**ROCKFORD BOARD OF EDUCATION
INVITATION FOR BID ON SUPPLIES, MATERIALS, EQUIPMENT OR SERVICES
FOR SCHOOL DISTRICT NO. 205
ROCKFORD, ILLINOIS**

IFB No. 22-23 HVAC & Roofing Projects at Lincoln, East, Washington & Flinn Schools

RE: **ADDENDUM NO. 9**

1 FIRST FLOOR DEMOLITION PLAN - AREA E
1/8" = 1'-0"

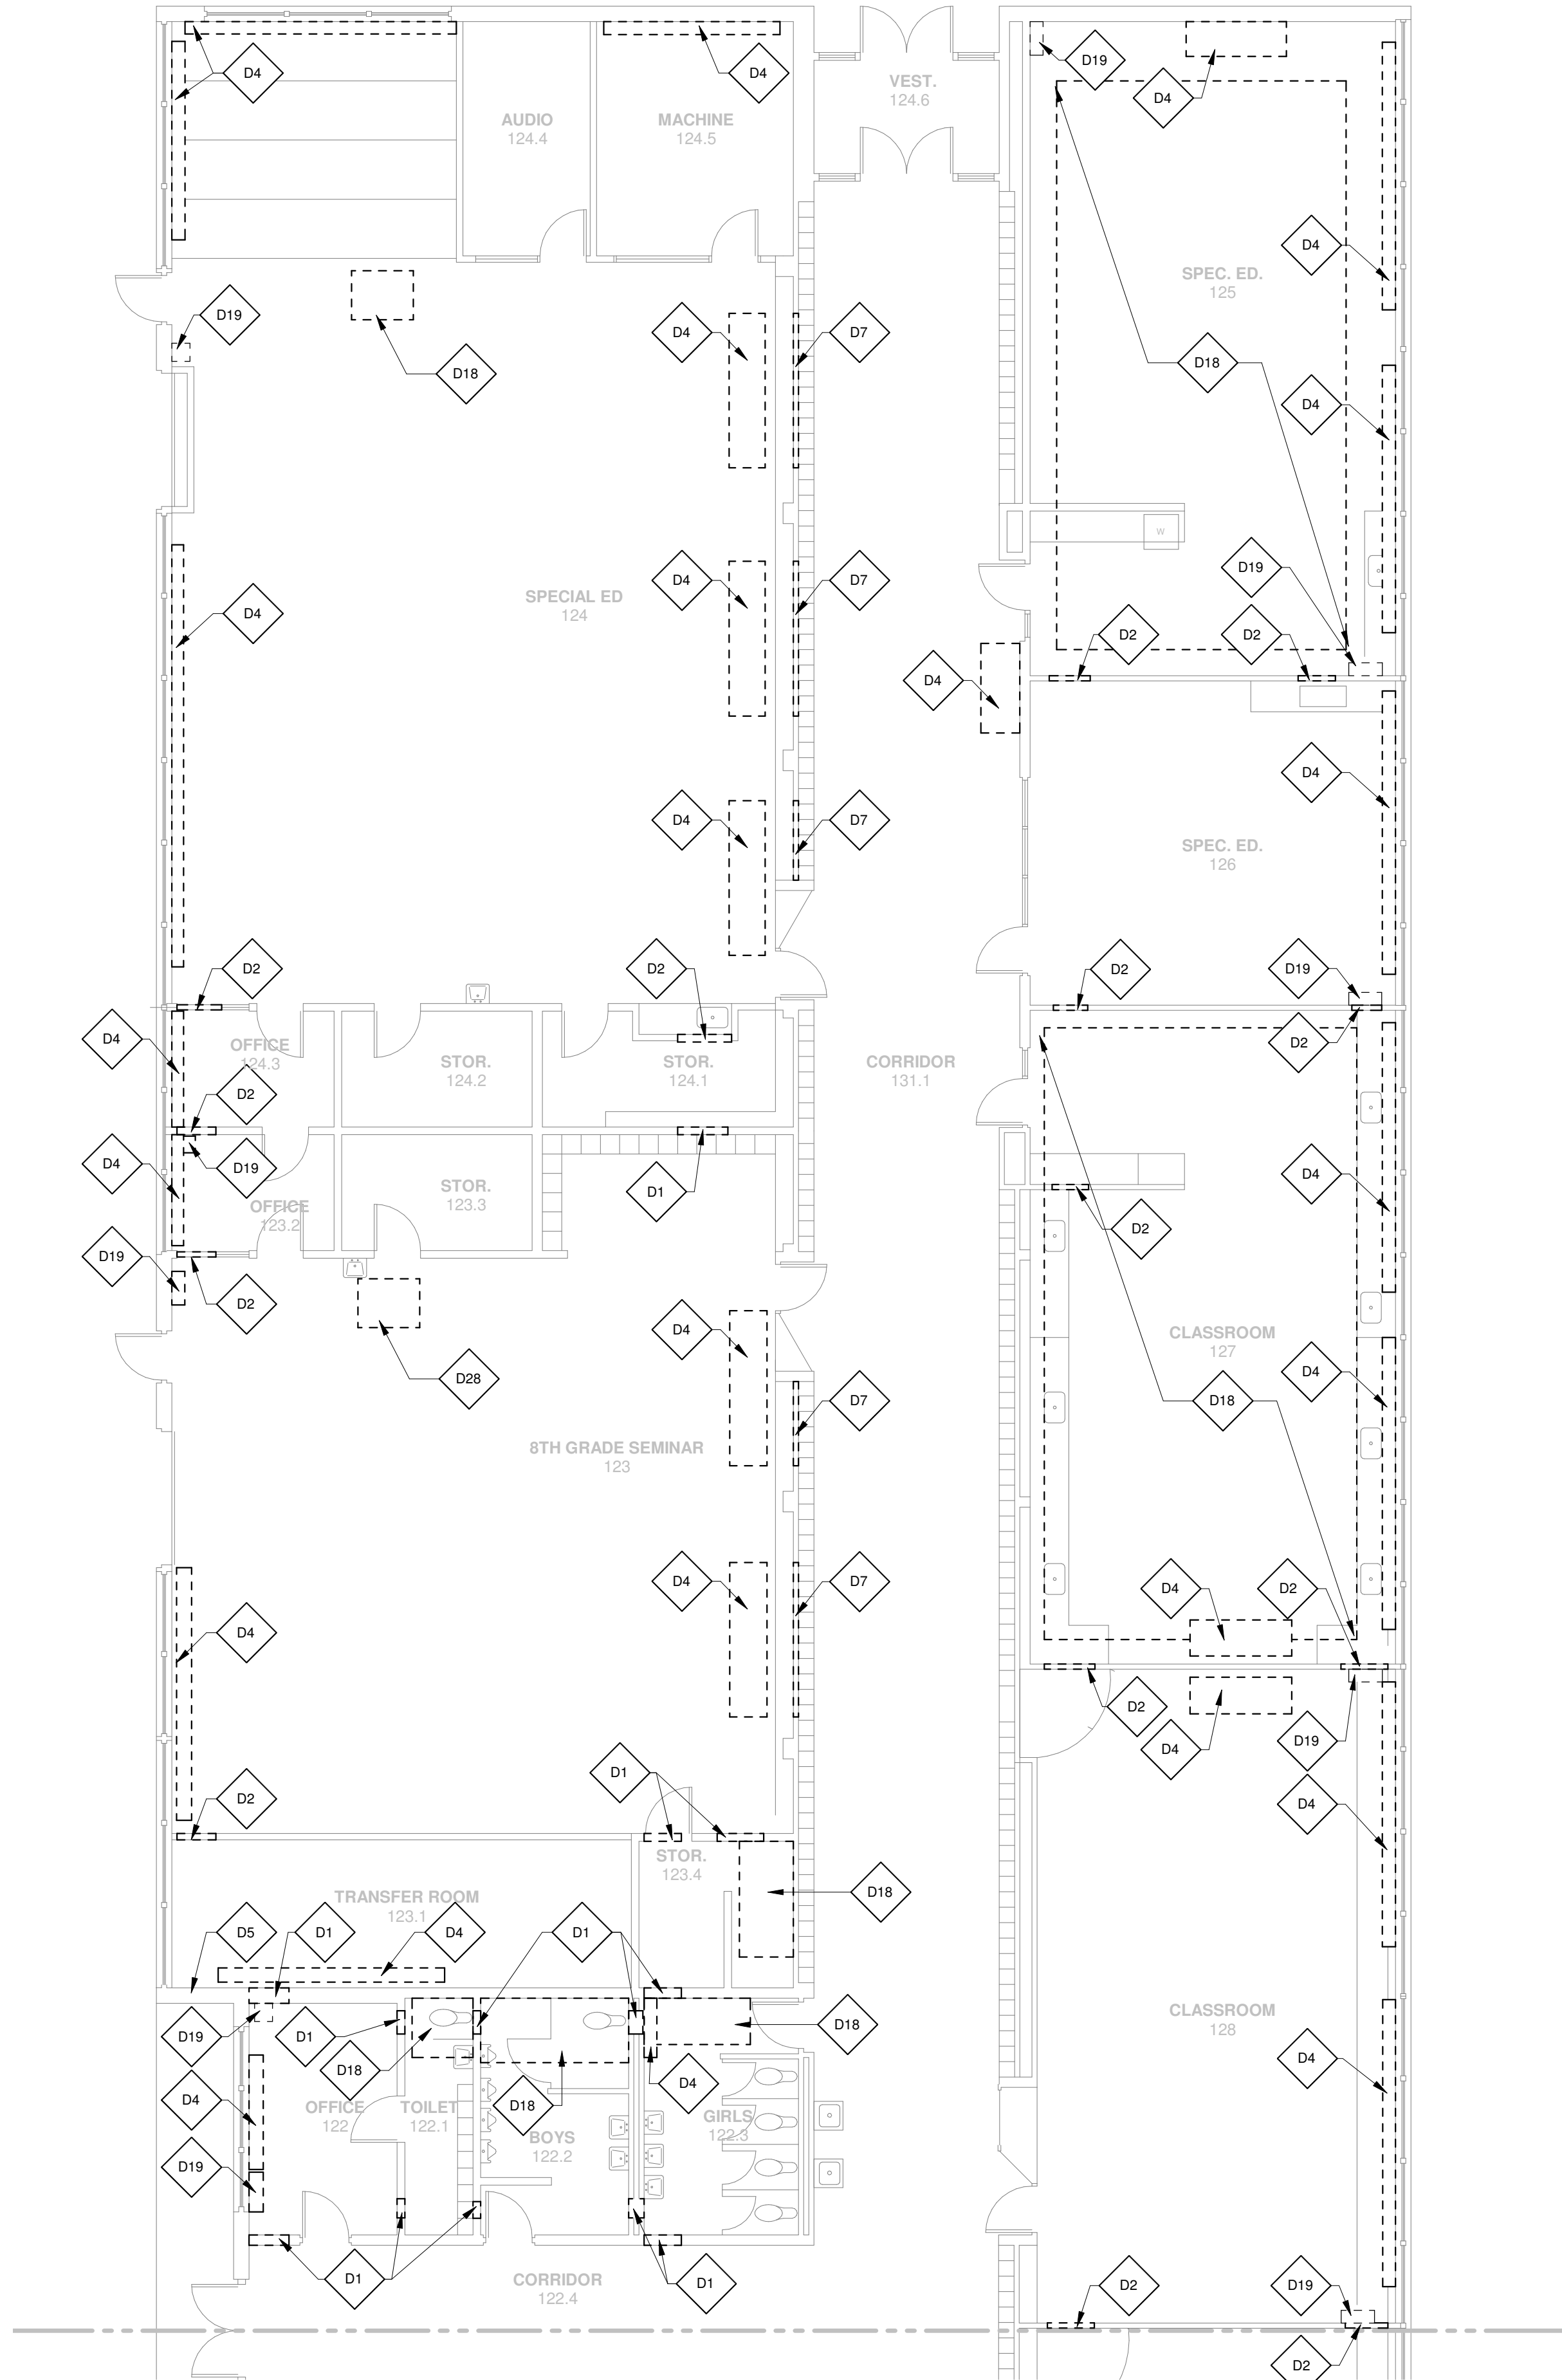
17. DRAWING D1.01E – FIRST FLOOR DEMOLITION PLAN – AREA E & F **REPLACE** entire sheet with D1.01E – FIRST FLOOR DEMOLITION PLAN – AREA E & F dated 03/10/2022.

SECOND FLOOR DEMOLITION PLAN - AREA A

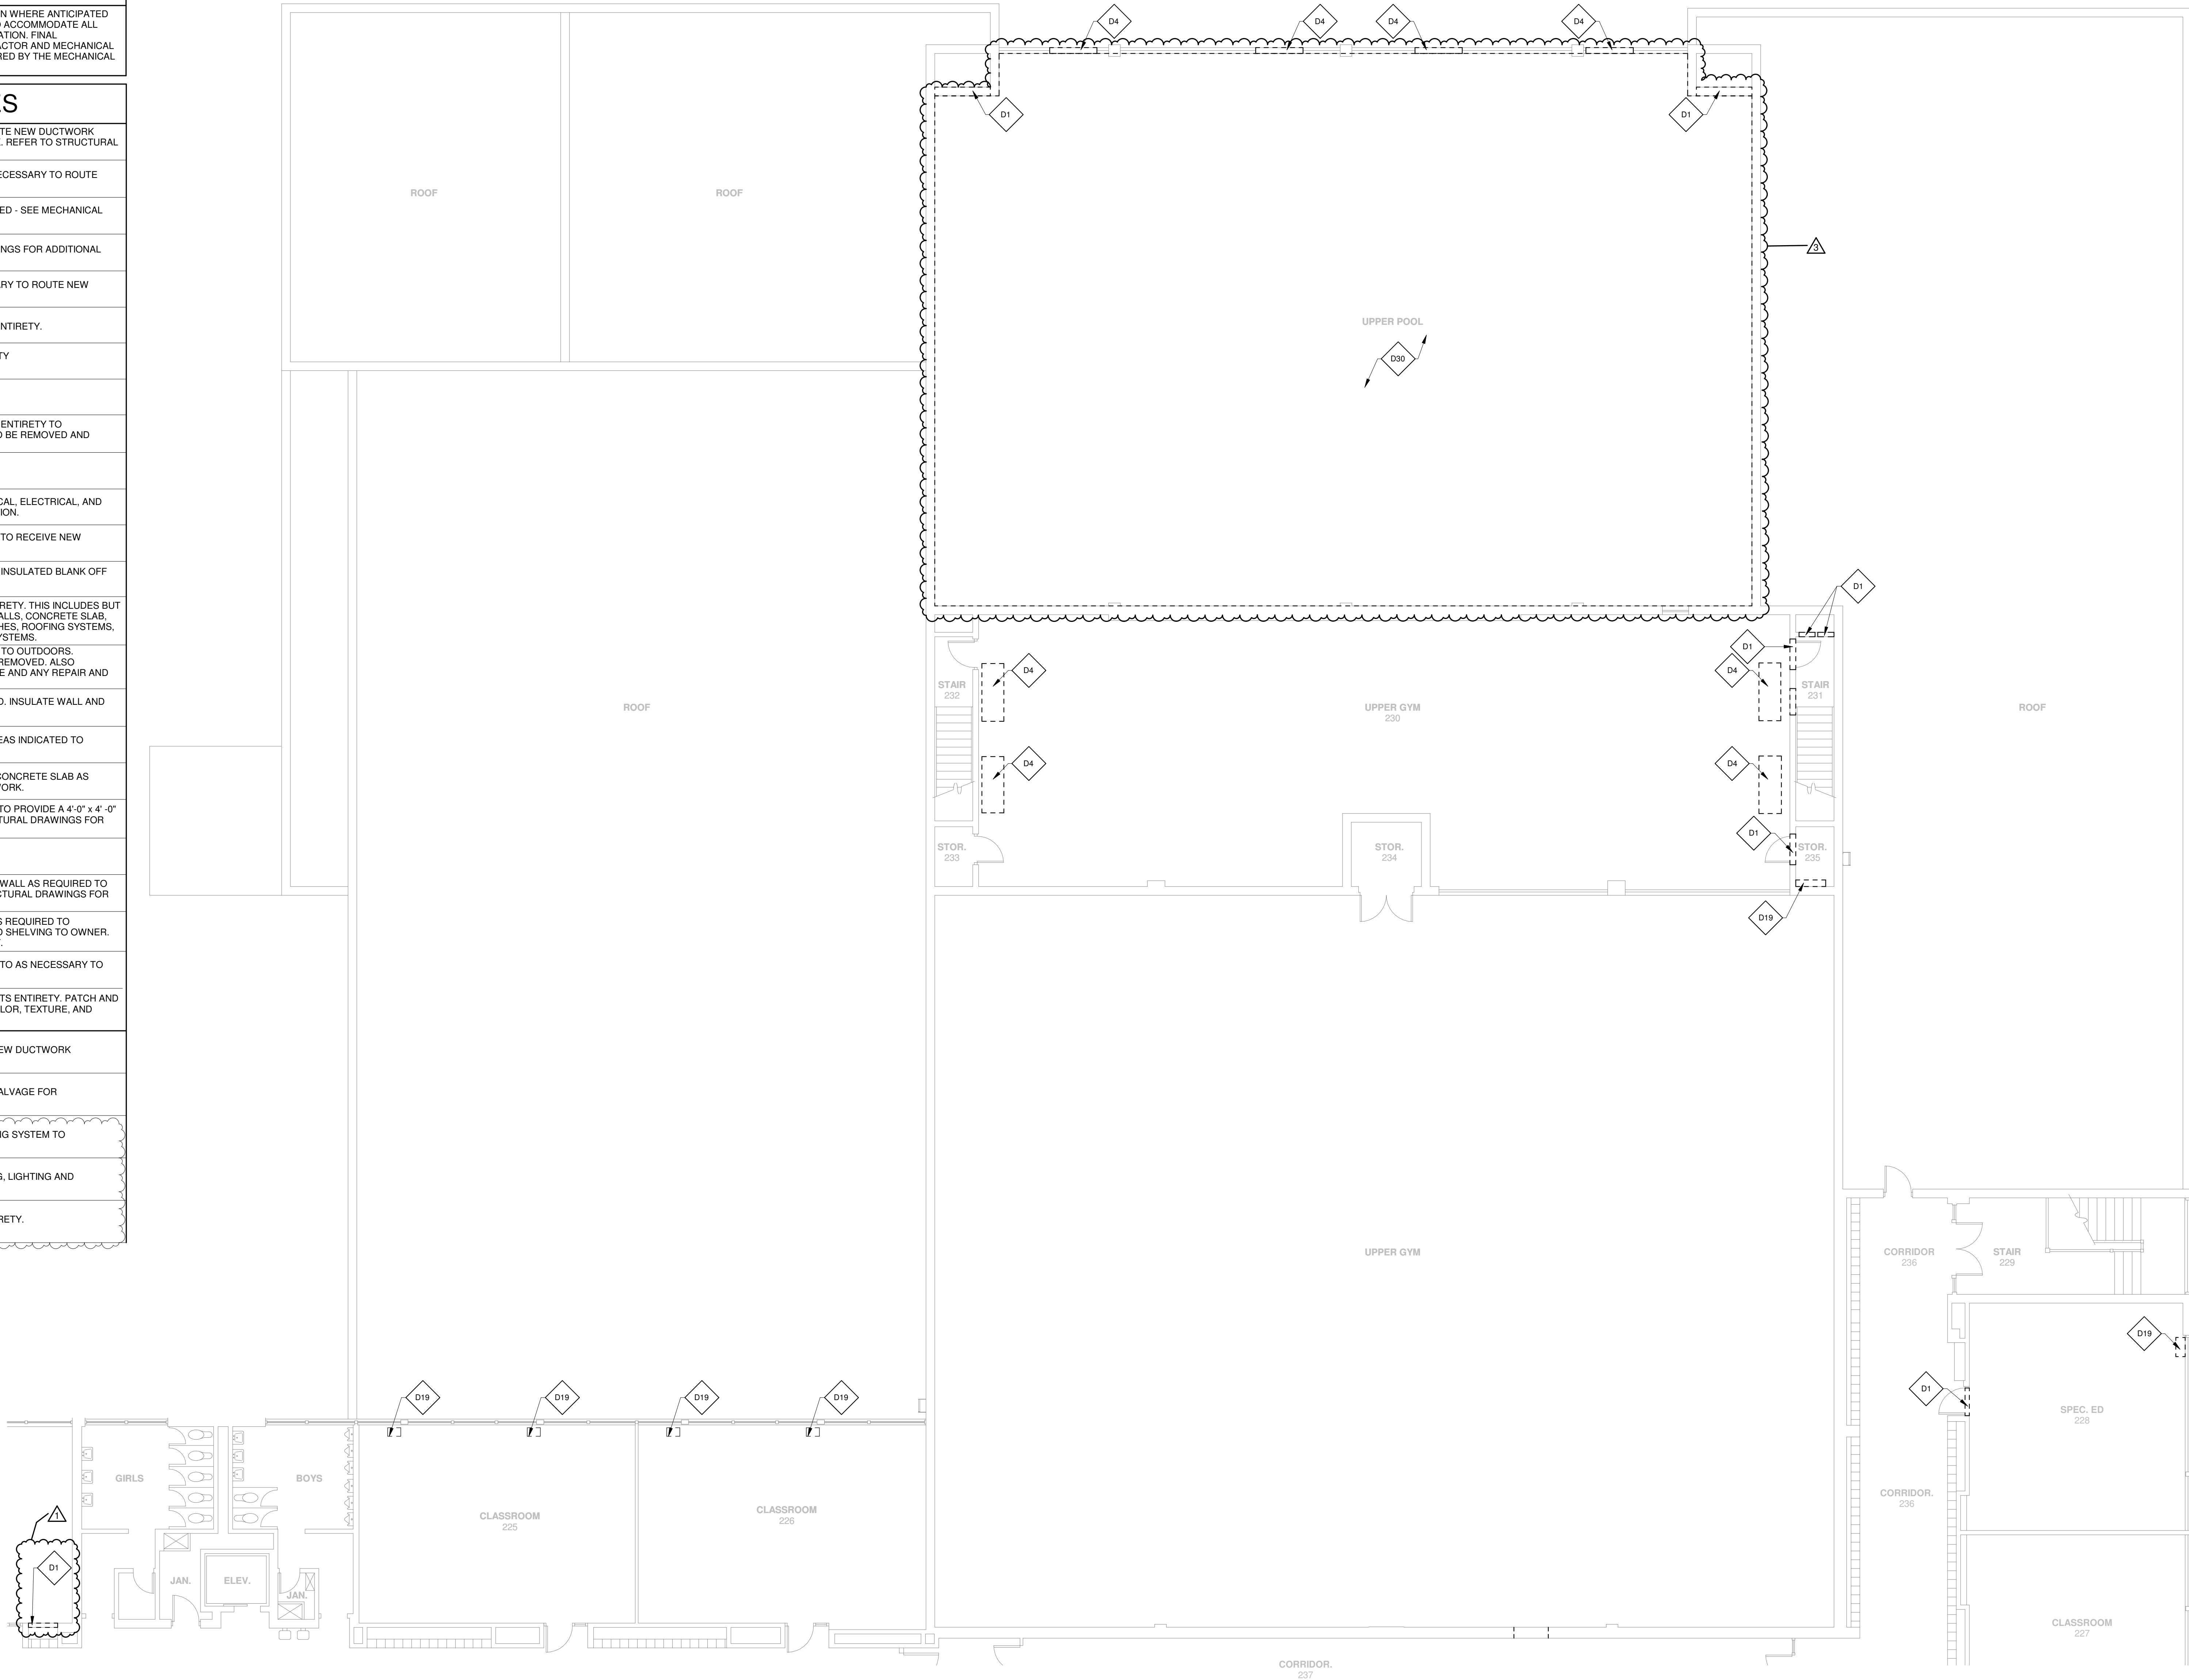
18. DRAWING D1.02A – SECOND FLOOR DEMOLITION PLAN – AREA A **ADD** entire sheet with D1.02A – SECOND FLOOR DEMOLITION PLAN – AREA A dated 03/10/2022.
 - a. **ADD** note “Remove existing aluminum ceiling in its entirety”.
